## NONCONFORMANCE REPORT

Project No. 20-01402-571

NCR No. 2002-08

One of the Alloy 22 weld qualification specimens CNWRA Drawing 20-01402-571-025 machined by Texas Toolmakers was not machined correctly. A detailed description of the non conformance items is provided below:

Alloy 22 Id Specimen  
CNWRA Drawing 20-01402-571-25  
All Dimensions  $\pm 0.010$ "  
unless otherwise specified  
Note: Detail A on Page 2

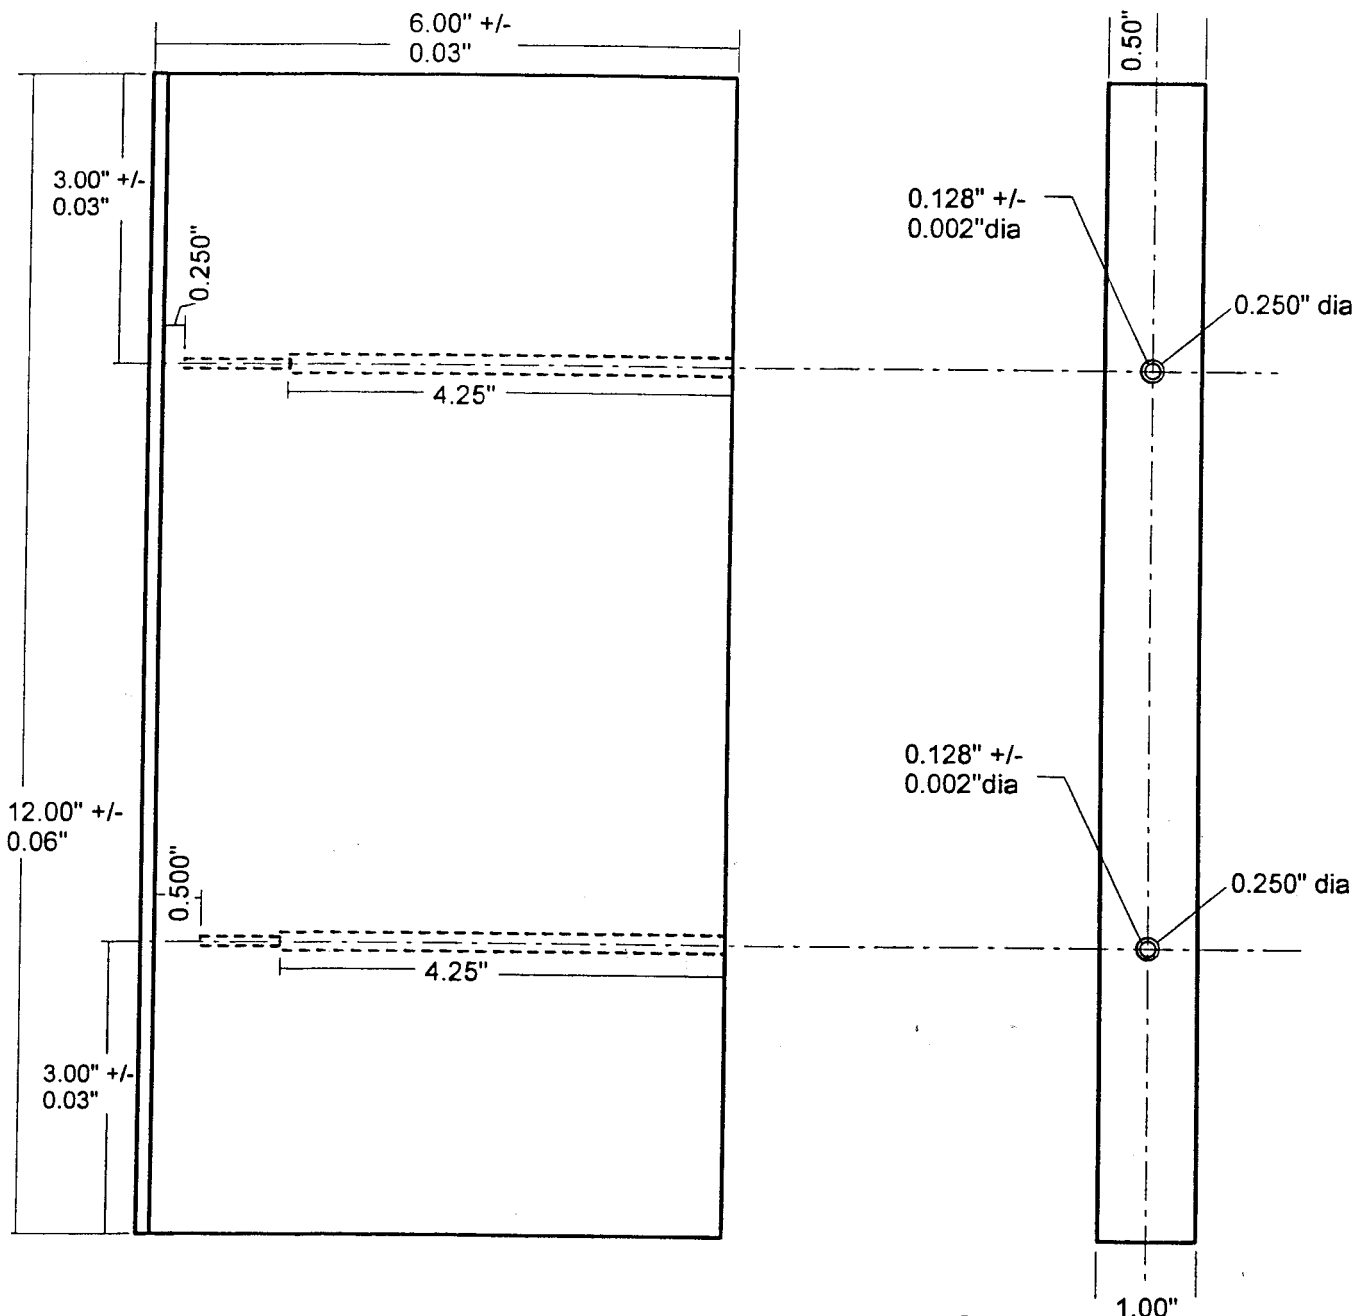
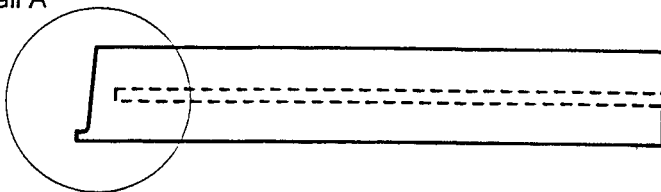
1. All plates: The 1.00 inch dimension (plate thickness) was not machined. Thickness of machined specimens was left as the nominal plate thickness.
2. Plate S/N 003: The 0.250 inch dimension was not recorded on the dimensional inspection for plate S/N 003.
3. Plate S/N 006: Thermocouple bore was machined too deep and has nearly penetrated through the weld joint surface.

Item #1: Plate thickness is not normally not machined for this type of specimen. Corrections to CNWRA Drawing 20-01402-571-25 are recommended. The 1.00 +/- 0.010 inch dimension for plate thickness should be changed to 1 inch nominal thickness.

<p><i>Item 1 - Drawing 20-1402-571-25 has been revised to reflect a 1" nominal thickness.</i></p> <p><b>PART 4: CLOSE OUT:</b></p> <p><i>Comments: Item #2 - Hole diameters were measured and found acceptable. Item #3 - Specimen 06 will not be used to qualify a welding procedure and will not be used for testing purposes. Ref Memo D. Dunn to B. Malita 3/24/03</i></p> <p>Verified by: <i>Mark R. Ehnstom</i> Date: <i>3/24/03</i></p>	<p><b>Distribution:</b></p> <p><i>20/55</i></p>
--	---
